Land South of Summer Lane, West of Pagham Road

Additional Diagrams

Southern Street Scenes - Key Plans

Roof Line Comparison Diagram - New street scene shows how the proposed homes have been varied in the street scene to ensure a variety of ridge heights

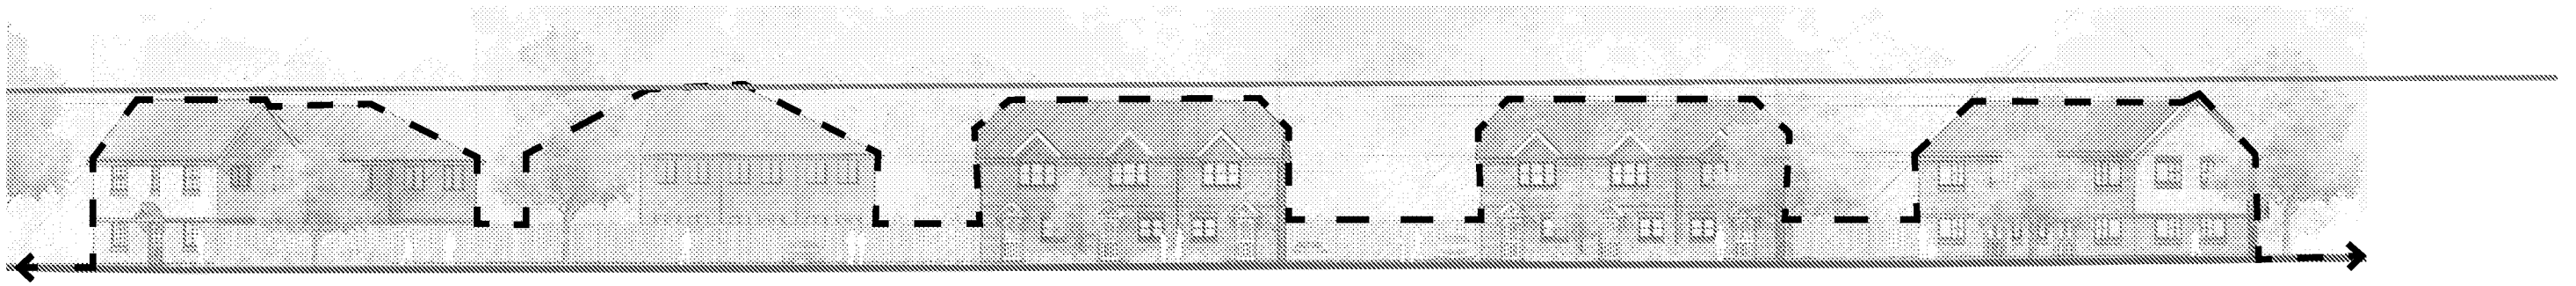
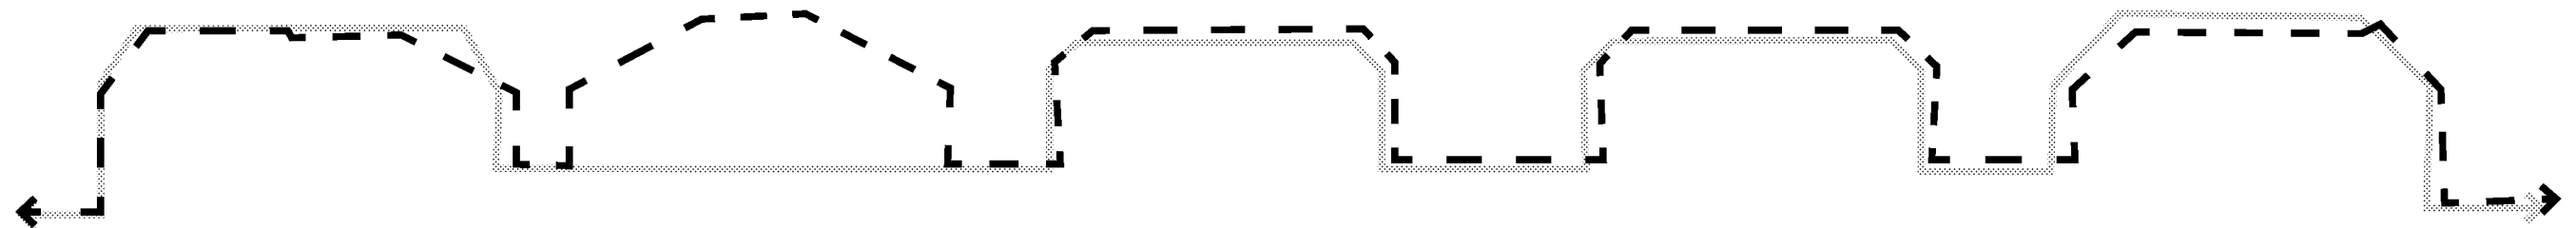
Roof Line of Previously Submitted Street Scene M-M CA4a - Roofs all of similar height, maximum roof height indicated in red.

Roof Line of New Street Scene P-P CA4a - Greater variation in roof height, buildings reoriented and reposition to increase active frontage, maximum roof height indicated in blue.

The following pages compare the previous rooflines with the newly proposed rooflines for each of the directly comparable street scenes on the southern parcel. These demonstrate how variety has been added into the street scene, particularly with the addition of buildings that feature lower eaves and ridge heights.

Roof Line Comparison Diagram - New street scene shows how the introduction of lower roofs adds variety to the street scene, and how the average roof height has been lowered overall

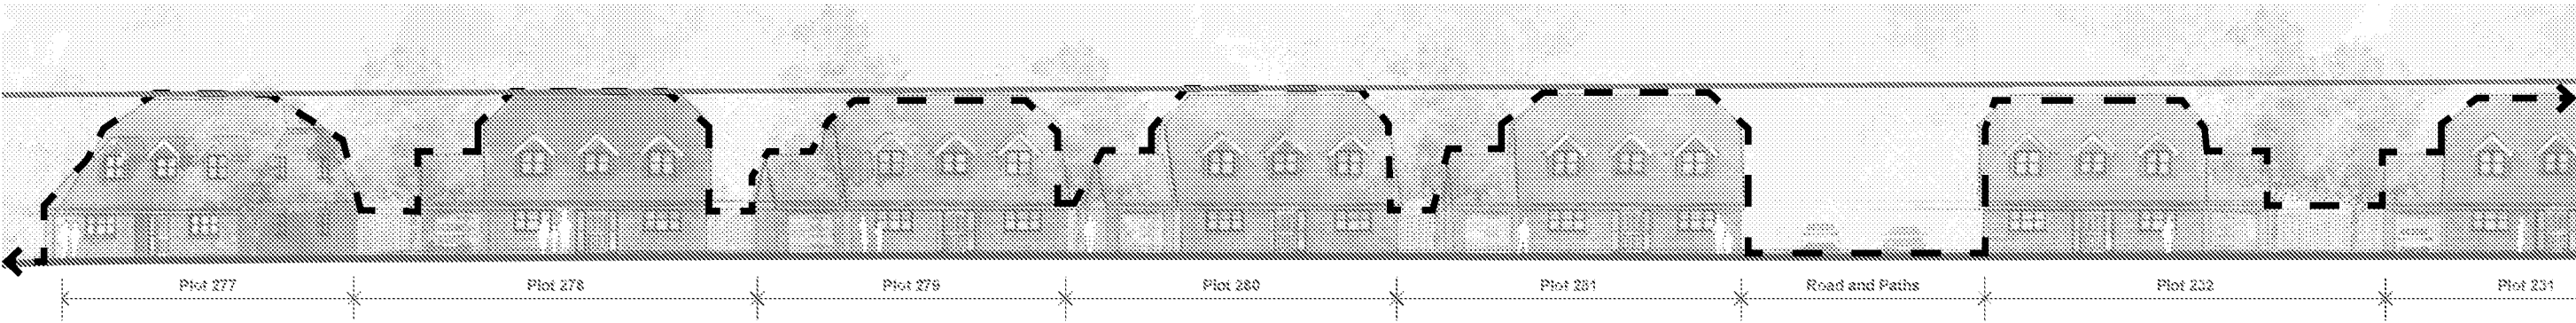
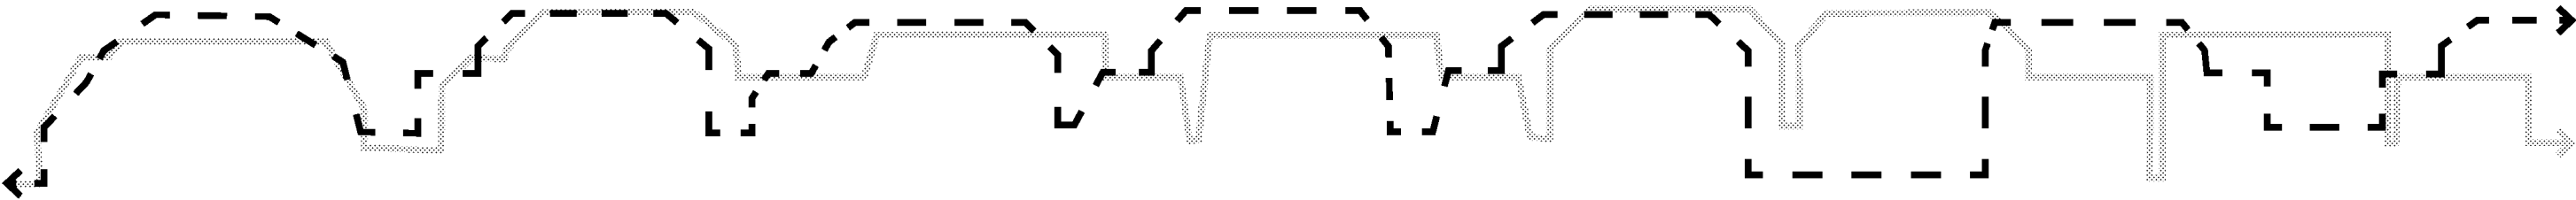
Roof Line of Previously Submitted Street Scene K-K CA4a - Roofs all of similar height, maximum roof height indicated in red.

Roof Line of New Street Scene M-M CA4a - Greater variation in roof height, maximum roof height indicated in blue.

Roof Line Comparison Diagram - New street scene shows how the proposed homes have been varied in the street scene to ensure a variety of ridge heights

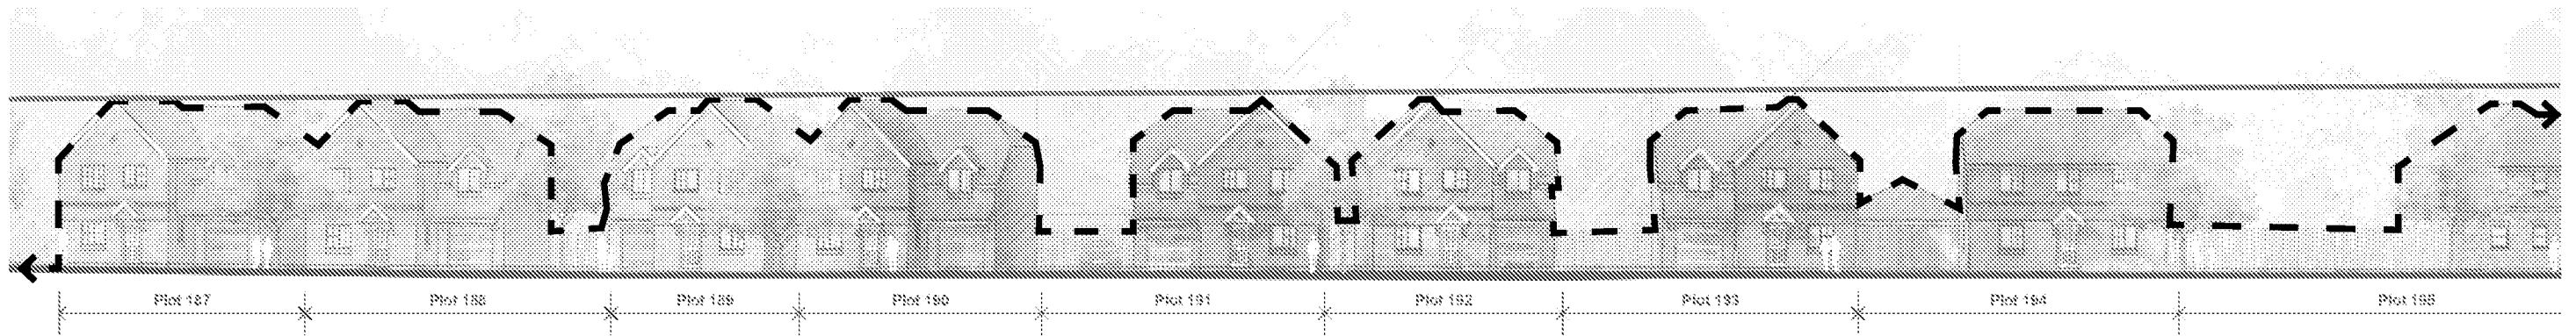
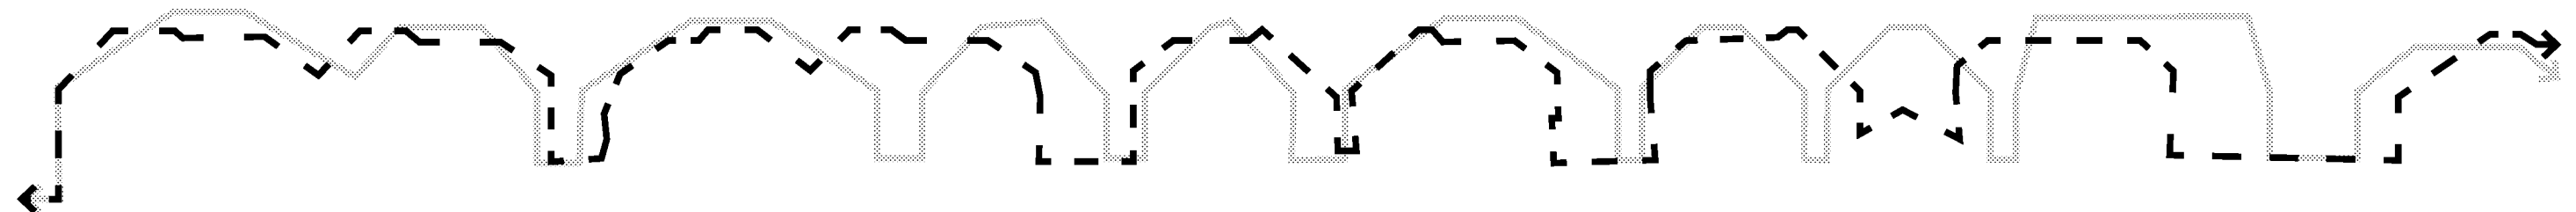
Roof Line of Previously Submitted Street Scene L-L CA2b - Roofs all of similar height, only two house types in the street scene, maximum roof height indicated in red.

Roof Line of New Street Scene N-NO CA2b - Greater variation in roof height due to range of house designs, maximum roof height indicated in blue.
